SUBJECT: SUMMARY OF AUGUST 26, 2022, PUBLIC OBSERVATIONAL
MEETING TO DISCUSS THE HOMESTAKE MINING COMPANY OF
CALIFORNIA'S LARGE TAILINGS PILE EVAPOTRANSPIRATION
COVER DESIGN LICENSE AMENDMENT REQUEST

**U.S Nuclear Regulatory Commission and Homestake Mining Company of California
Public Observational Meeting, Large Tailings Pile Evapotranspiration Cover
License Amendment Request, Grants Reclamation Project August 26, 2022
Talking Points**

Figure 1. Dispersive Potential vs. TDS (Source: Figure 4 of USBR, 1991)

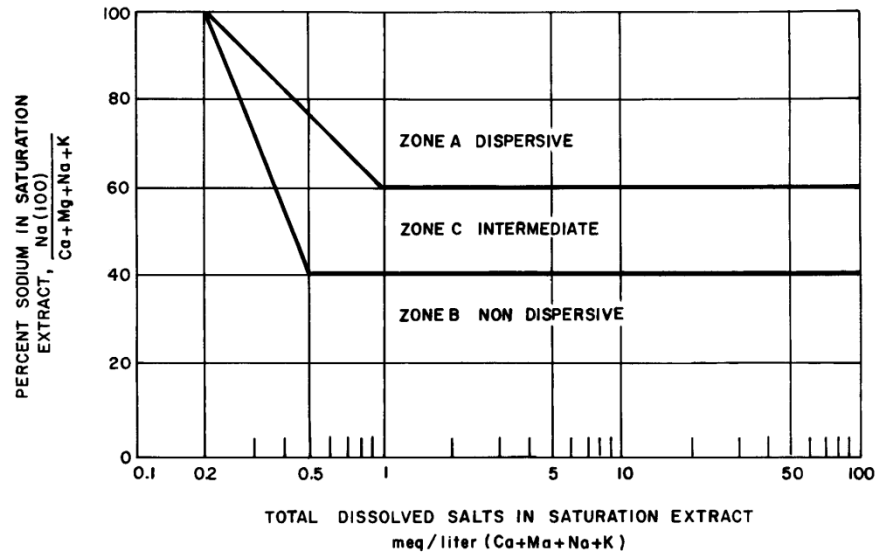
Using the concentrations of Ca, Mg, Na, and K provided in Table 2 of Appendix C, the staff calculated the percent Na to determine the soil dispersive potential using a relationship between total dissolved salts (TDS) (refer to Figure 1, U.S. Bureau of Reclamation (USBR); 1991¹). As shown in Table 1, many of the samples appear to be dispersive or fall within the intermediate range. Due to the highly erosive nature of dispersive soils, the staff determined that additional field testing is necessary to better characterize the proposed soils for the ET cover and radon barrier². Methods for determining dispersive soils include the crumb test (American Society for Testing and Materials (ASTM) D6572), pinhole test (D4647/D4647M), the double hydrometer test (ASTM D4221), and the analysis of pore water extraction (ASTM D4542). According to ASTM D6572, the crumb test should usually be performed in conjunction with the other tests since this test may not identify all dispersive clay soils.
